Access Compliance Report

Public Rights-of-Way

(Curb Ramps)

Intersection ID: 28346	Main Street: DICKIE_ROSS_RD	Cross Street: SCOTLAND_HALL_CT	Location: SE
ADA ID: 76DA525F4C1B	Ramp Type: BlendTrans1	Initial Pass/Fail: Fail	Overall Compliance: No
Severity Score: 10			
Codes/Mitigation Info/Possible Solution		Field Measurements/Component Compliance

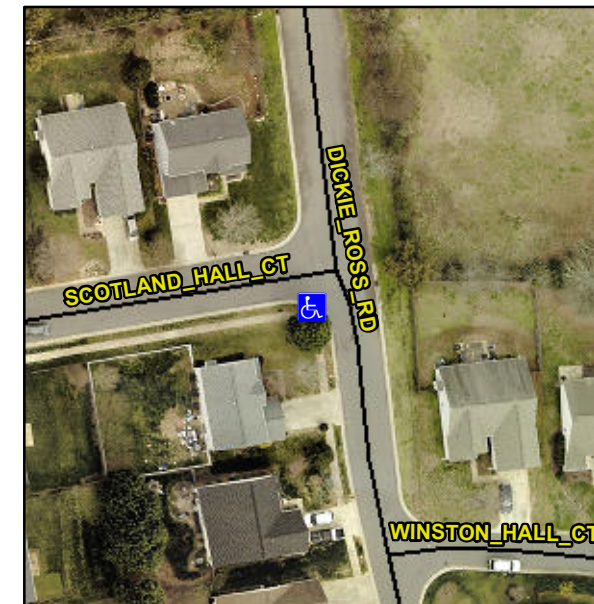
R304.5.1, R304.5.3

Compliance	Description	Data	Compliance	Description	Data
N/A	Ramp Length (in)	46.0	Yes	BlendTrans Slope (%)	1.8
No	Ramp Width (in)	42.0	No	BlendTrans XSlope (%)	2.7
N/A	Flare Type LT	N/A	N/A	Flare Type RT	N/A
N/A	Flare Slope LT (%)	N/A	N/A	Flare Slope RT (%)	N/A
N/A	Flare Traversable LT?	N/A	N/A	Flare Traversable RT?	N/A
N/A	Landing Length (in)	N/A	N/A	DWS Provided?	N/A
N/A	Landing Width (in)	N/A	N/A	DWS Contrast?	N/A
N/A	Landing Slope (%)	N/A	N/A	DWS Length (in)	N/A
N/A	Landing X Slope (%)	N/A	N/A	DWS Full Width?	N/A
N/A	Landing Curb? (Y/N)	N/A	N/A	DWS Offset (in)	N/A
N/A	Shared Landing?	N/A			
N/A	Gutter Ponding?	N/A	N/A	Gutter Slope (%)	N/A
N/A	Gutter Lip Ht (in)	N/A	N/A	Gutter X Slope (%)	N/A
N/A	Painted X Walk1?	No	N/A	Painted X Walk2?	No
	X Walk 1 Direction	To E		X Walk 2 Direction	To N
	X Walk 1 Width (in)	N/A		X Walk 2 Width (in)	N/A
	X Walk 1 Slope (%)	0.8		X Walk 2 Slope (%)	N/A
	X Walk 1 X Slope (%)	4.0		X Walk 2 X Slope (%)	N/A

N/A	Ramp inside XWalk1?	N/A	N/A	Ramp inside XWalk2?	N/A
	Road Slope (%)	0.8		Clear Space?	N/A
	Road X Slope (%)	4.0	N/A	Clear Space to XWalk (in)	N/A
N/A	Any Obstructions?	N/A	N/A	Storm Grate/Utility Hazard?	N/A
	Obstruction Type			Storm Grate/Utility Type	
		N/A			N/A
			Yes	Surface Condition? (G/P)	Good
			N/A	Curb Slope (%)	3.0

Remove & Replace Curb Ramp With Two New Directional Ramps or Equivalent.
